Access Compliance Report

Public Rights-of-Way

(Pedestrian Signals)

Intersection ID: N/A	Main Street:	Cross Street: N/A	Location: N/A
ADA ID: 46B7C62BA573	Signal Type: One Push Button-Non APS	Overall Compliance: No	Severity Score: BTN 1: N/A BTN 2: N/A No BTN: N/A
Codes/Mitigation Info/Possible Solution		Field Measurements/Component Compliance

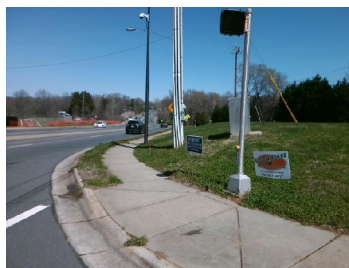
PROW/ADA: TMUTCD 4e.08, R404.2, R404.3, R404.7.2

N/A	B 1 FWD Approach Width (in)	N/A	N/A	B 2 FWD Approach Width (in)	N/A
N/A	B 1 FWD Approach Obstruction?	Yes	N/A	B 2 FWD Approach Obstruction?	N/A
N/A	B 1 FWD Approach Obstruction Dist (in)	2.0	N/A	B 2 FWD Approach ObstructionDist (in)	N/A
N/A	B 1 PARA Approach?	Yes	N/A	B 2 PARA Approach?	N/A
N/A	B 1 PARA Approach Constrained?	Yes	N/A	B 2 PARA Approach Constrained?	N/A
Yes	B 1 PARA Approach Reach (in)	6.0	N/A	B 2 PARA Approach Reach (in)	N/A
No	B 1 PARA Approach Width (in)	48.0	N/A	B 2 PARA Approach Width (in)	N/A
N/A	B 1 PARA Approach Obstruction?	Yes	N/A	B 2 PARA Approach Obstruction?	N/A
N/A	B 1 PARA Approach Obstruction Dist (in)	3.0	N/A	B 2 PARA Approach ObstructionDist (in)	N/A
No	B 1 Clear Floor Space Slope (%)	9.7	N/A	B 2 Clear Floor Space Slope (%)	N/A
No	B 1 Clear Floor Space XSlope (%)	3.8	N/A	B 2 Clear Floor Space XSlope (%)	N/A
N/A	B 1 PAR Slope (%)	N/A	N/A	B 2 PAR Slope (%)	N/A
Yes	B 1 Height (in)	36.0	N/A	B 2 Height (in)	N/A

N/A	B 1 Clear Xing Direction?	Yes	N/A	B 2 Clear Xing Direction?	N/A
	B 1 Crossing Direction	To S		B 2 Crossing Direction	N/A
Yes	B 1 DistanceTo XWalk (in)	22.0	N/A	B 2 DistanceTo XWalk (in)	N/A
No	B 1 DistanceTo Curb (in)	85.0	N/A	B 2 DistanceTo Curb (in)	N/A
Yes	B 1 Diameter (in)	2.0	N/A	B 2 Diameter (in)	N/A

Possible Solutions: Replace Signal Push Button With APS Button on New Post. Remove & Relocate Sign.
